ENGINEERING CHANGE PROPOSAL (ECP), PAGE 1

c. SYSTEM DESIGNATION: M260 & M261 ROCKET LAUNCHER

d. ECP NO.: MI-M7565

13. TITLE OF CHANGE: ELIMINATION OF UNNESSECCARY HOLE, CONNECTOR MODIFICATION AND COMBINATION OF TWO PARTS

ECP NO. MI-M7565 NOR 13/18 SHEET 2 OF 3

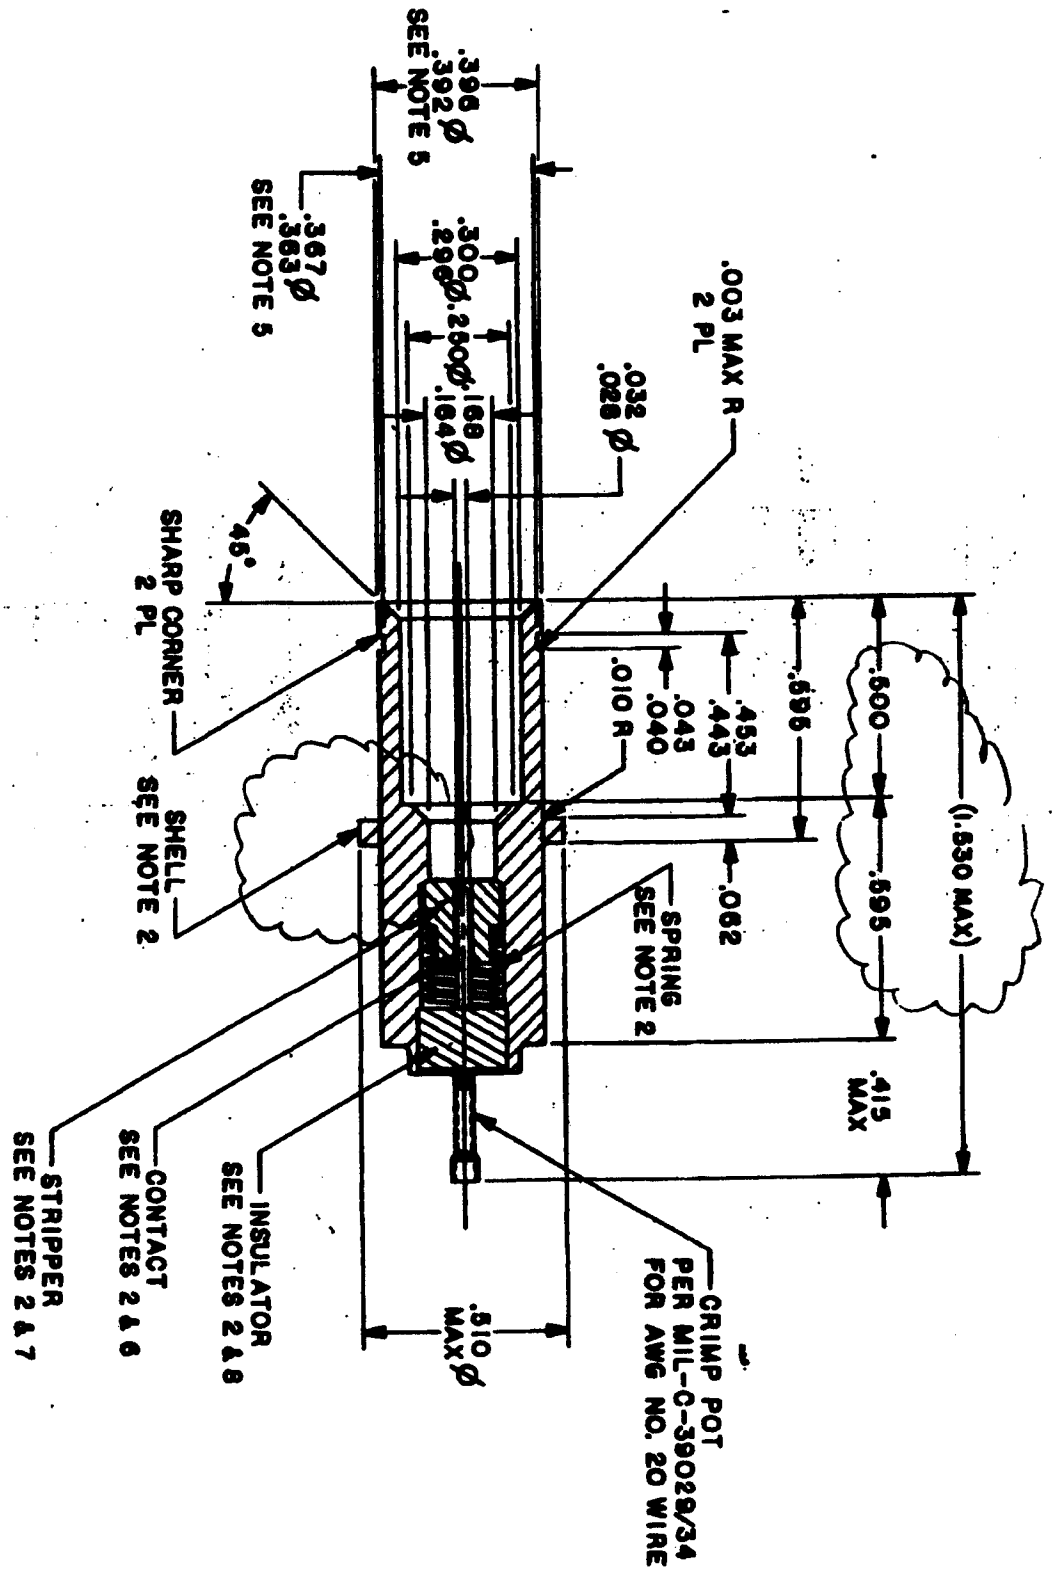
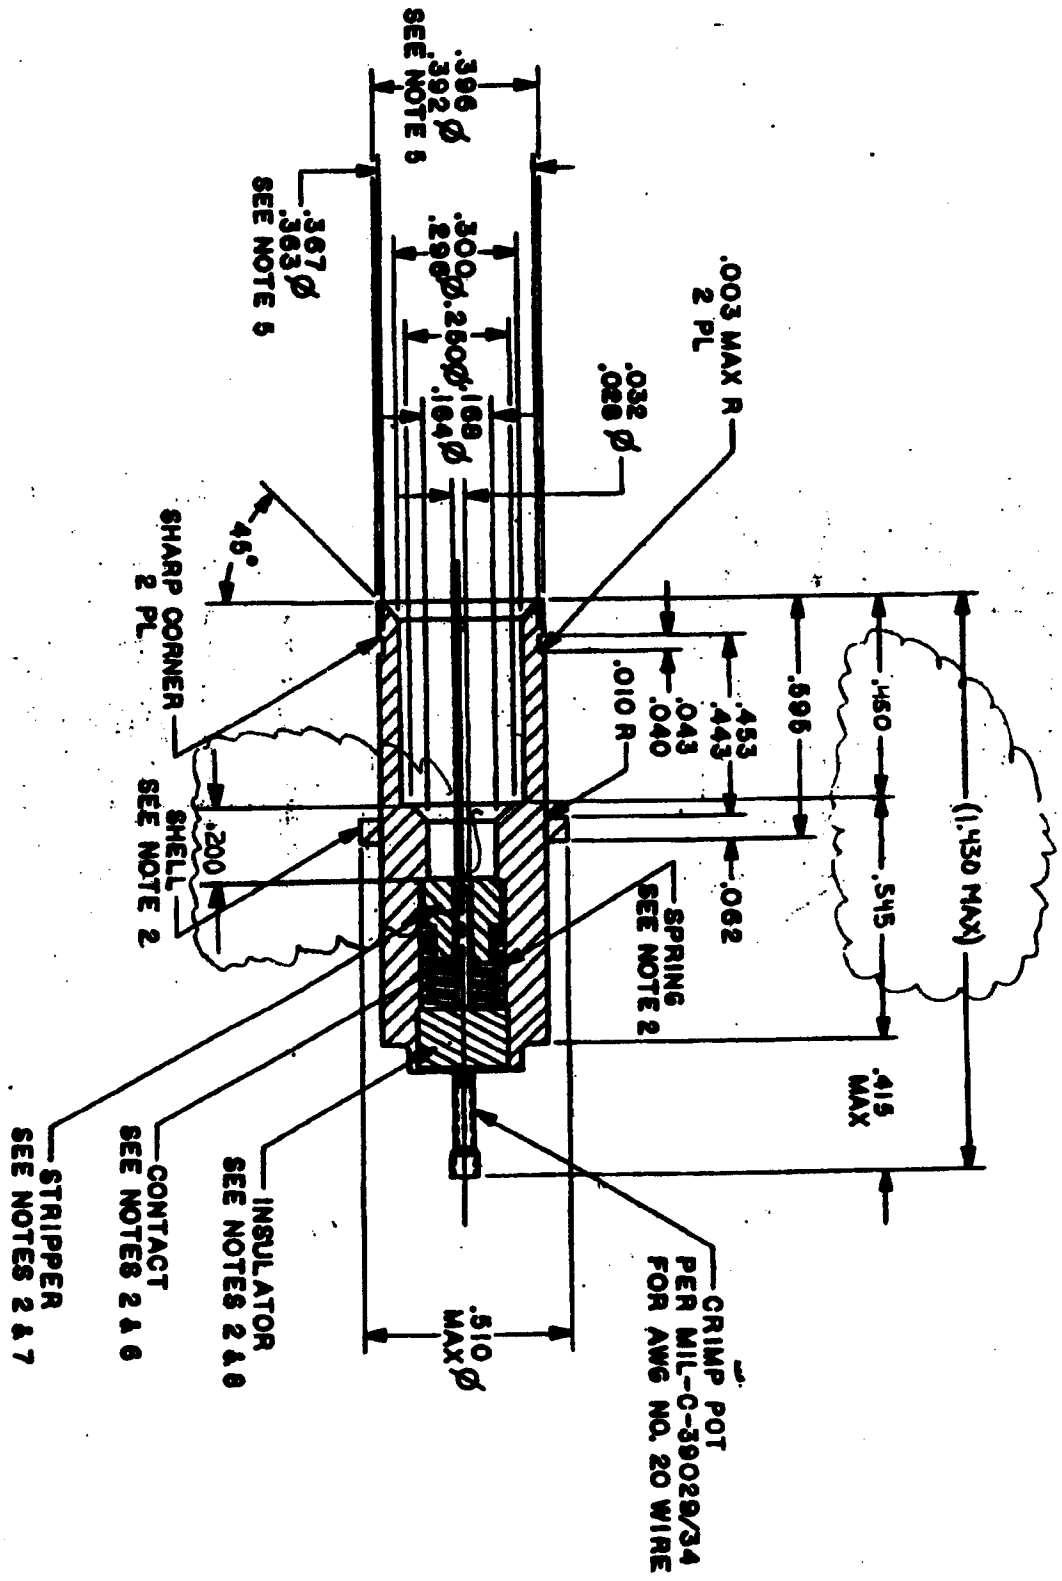
THE DRAWING HAS BEEN REVISED AND REDRAWN ON SHEETS 2 THRU 3. THE CLOUDS DEPICT THE AREAS OF CHANGE.

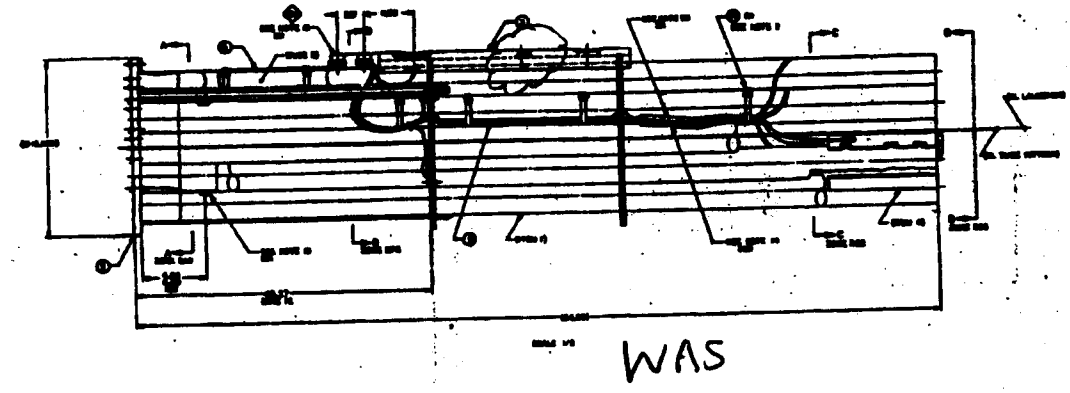
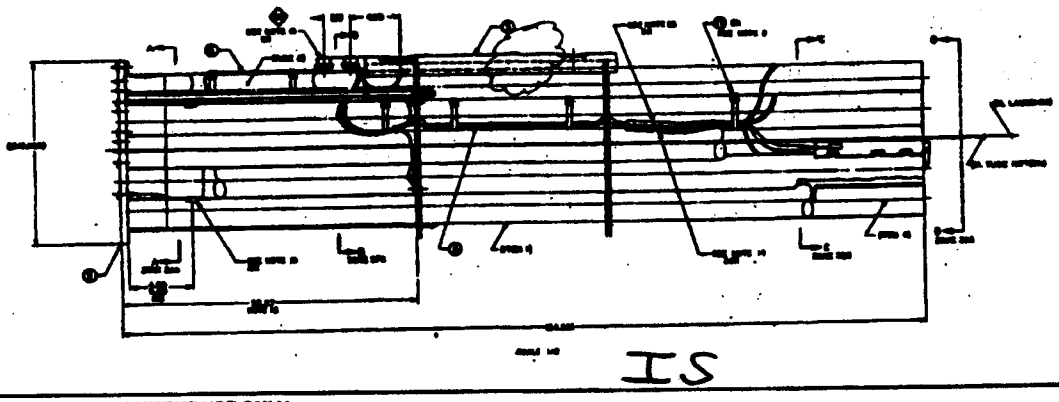
THE DRAWING HAS BEEN REVISED AND REDRAWN. THE CLOUDS DEPICT THE AREAS OF CHANGE.

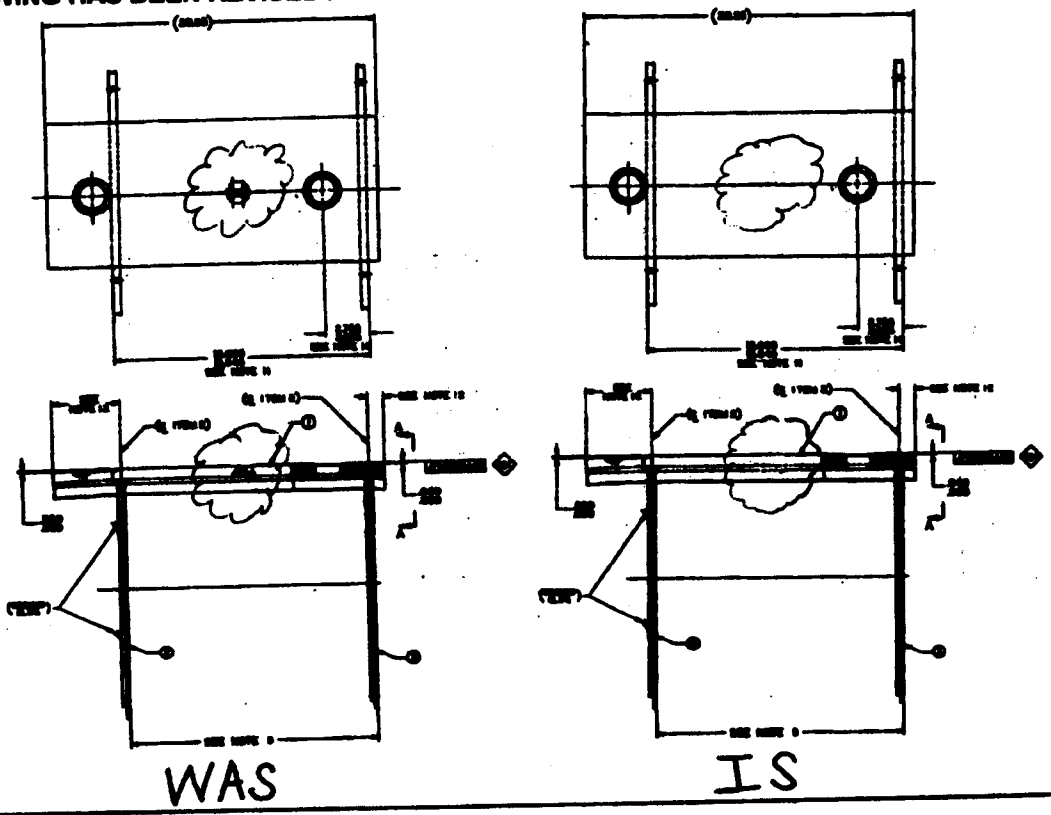
13. DESCRIPTION OF REVISION
THE DRAWING HAS BEEN REVISED AND REDRAWN. THE CLOUDS DEPICT THE AREAS OF CHANGE.

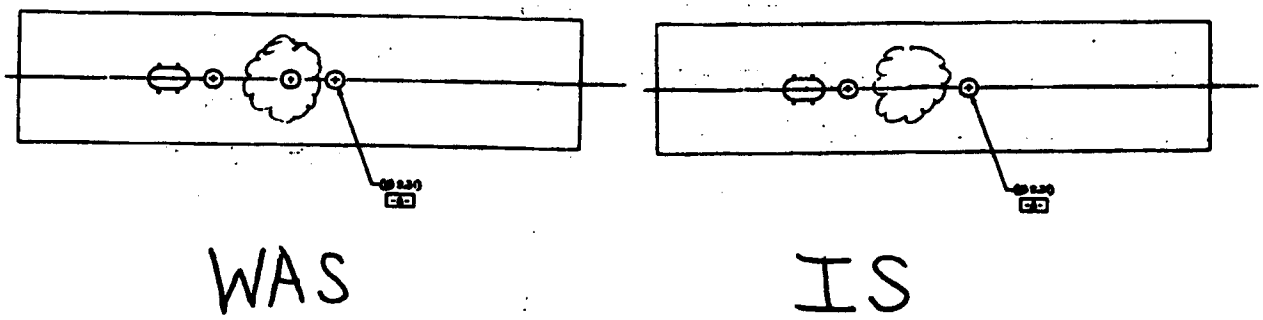
13. DESCRIPTION OF REVISION
THE DRAWING HAS BEEN REVISED AND REDRAWN. THE CLOUDS DEPICT THE AREAS OF CHANGE.

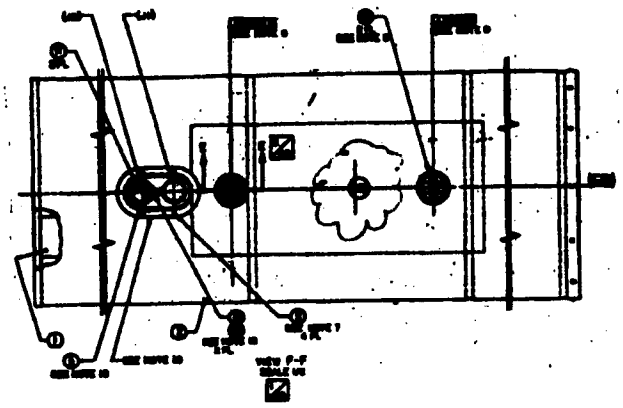
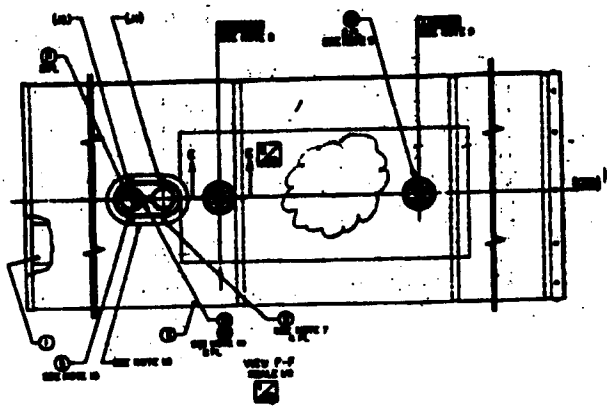
THE DRAWING HAS BEEN REVISED AND REDRAWN. THE CLOUDS DEPICT THE AREAS OF CHANGE.

ECP NO. MI-M7565 NOR 18/18 SHEET 2 OF 3

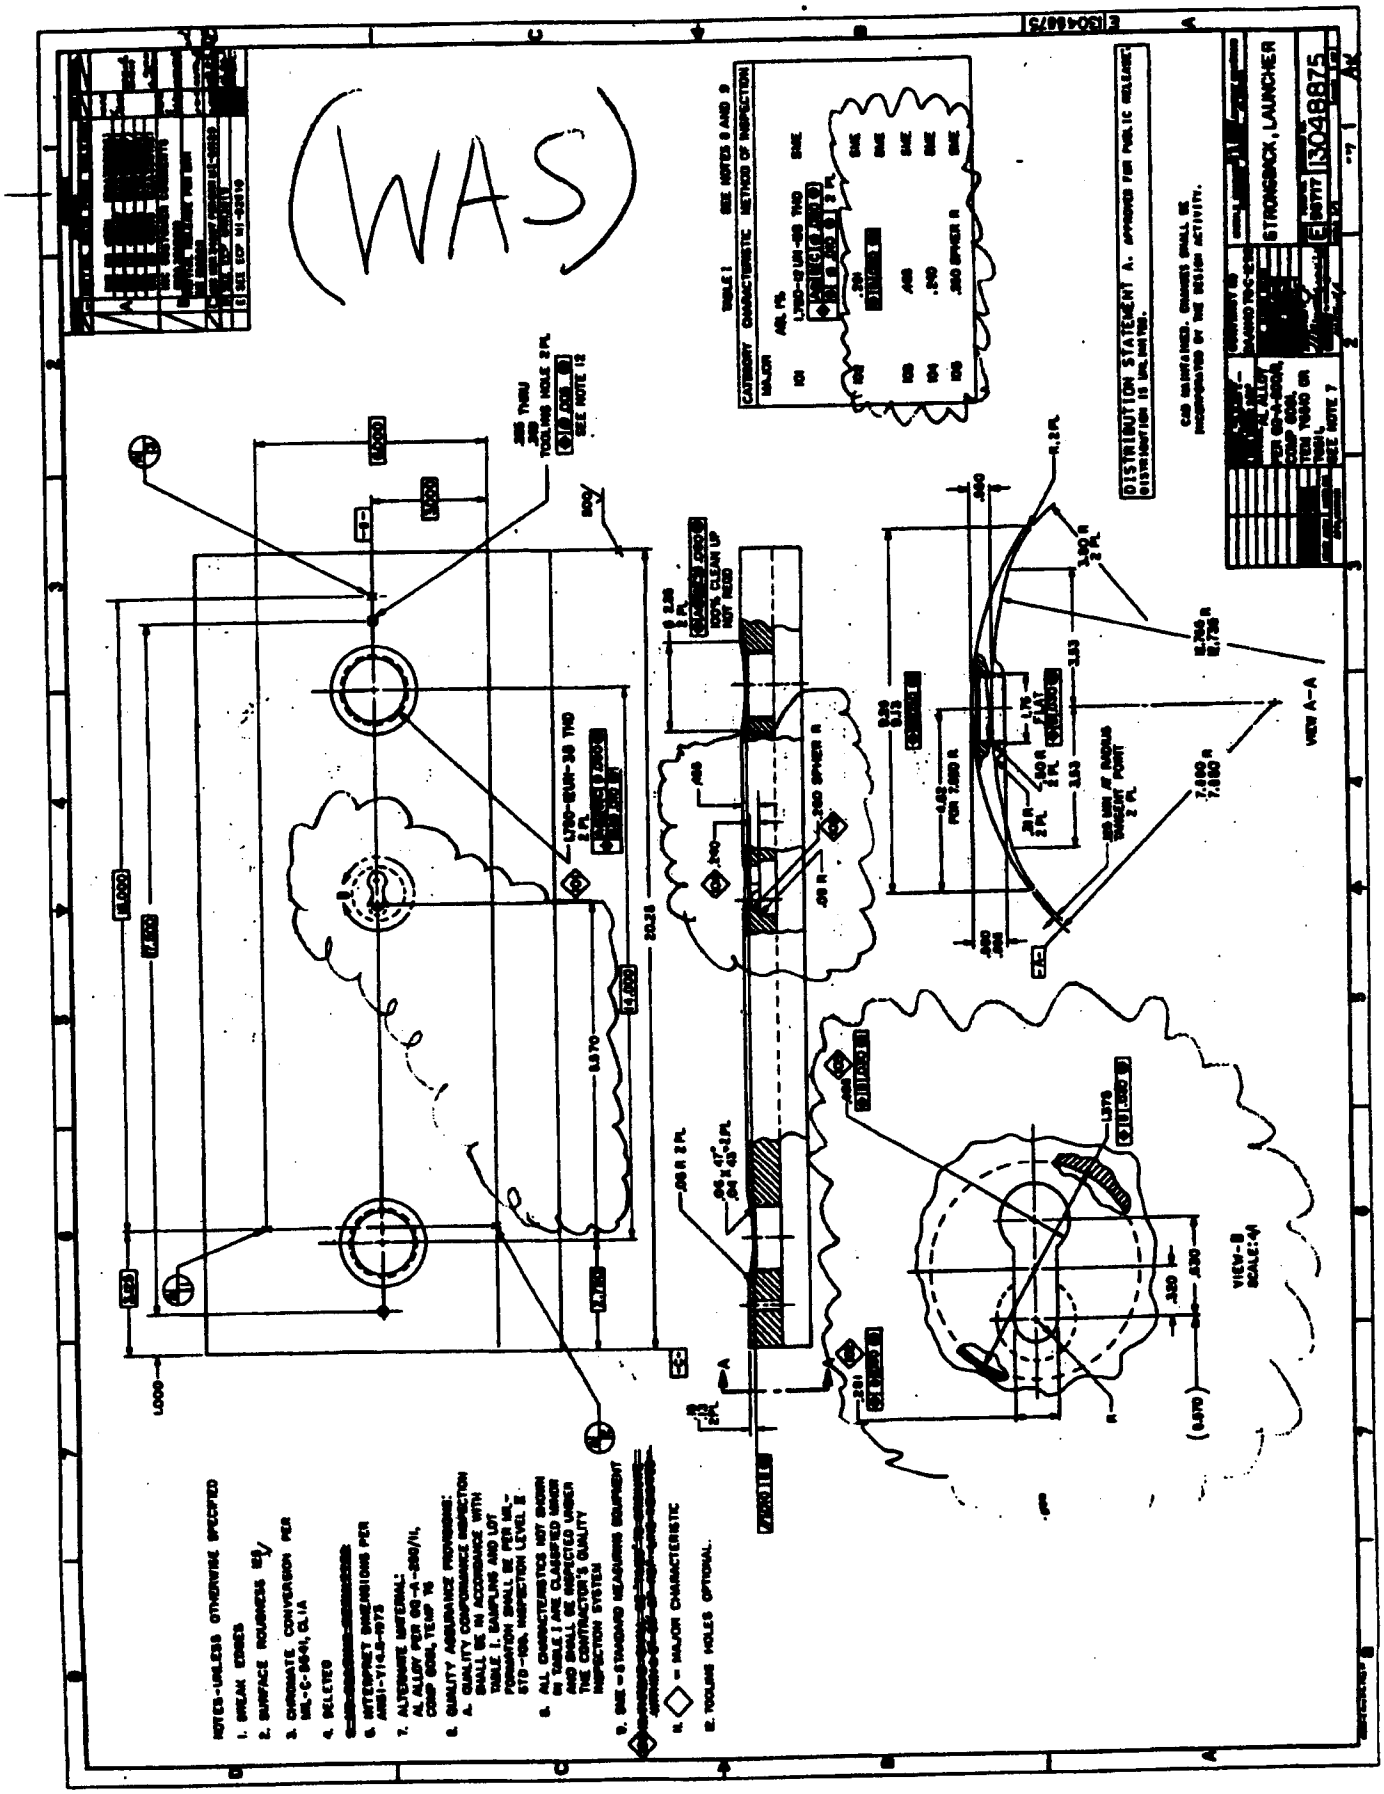
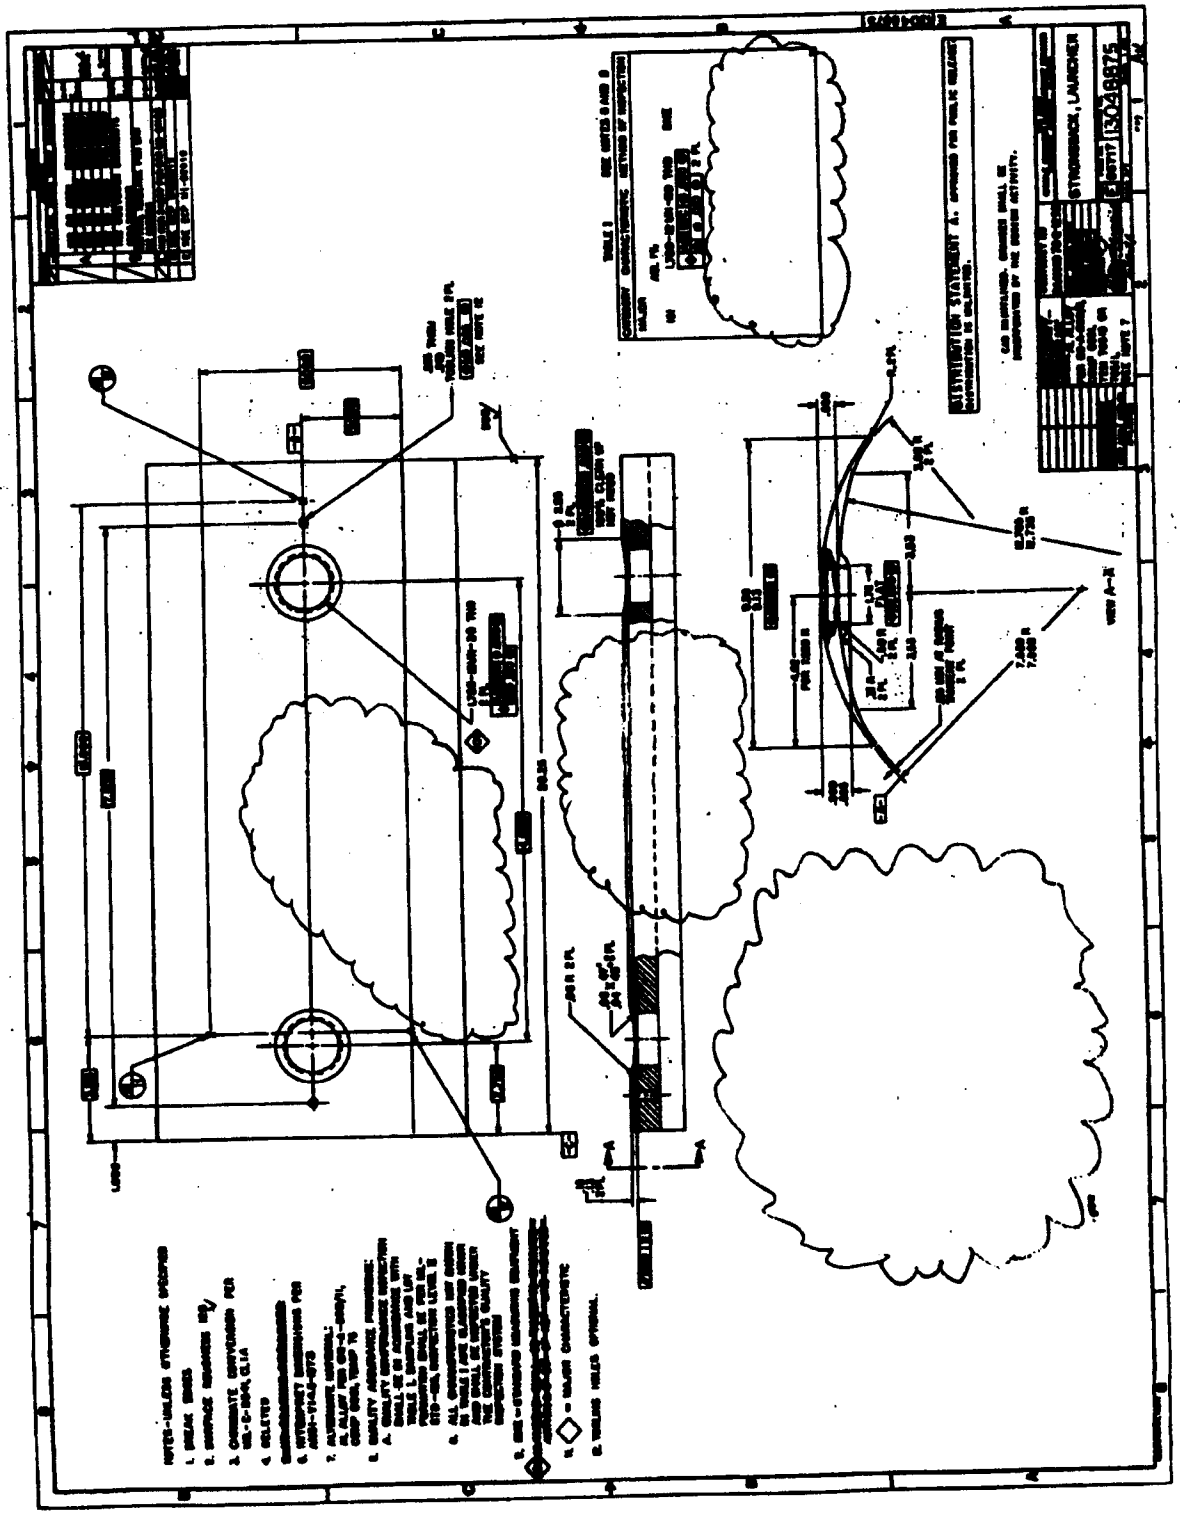
13. DESCRIPTION OF REVISION
THE DRAWING HAS BEEN REVISED AND REDRAWN ON SHEETS 2 THRU 3. THE CLOUDS DEPICT THE AREAS OF CHANGE.
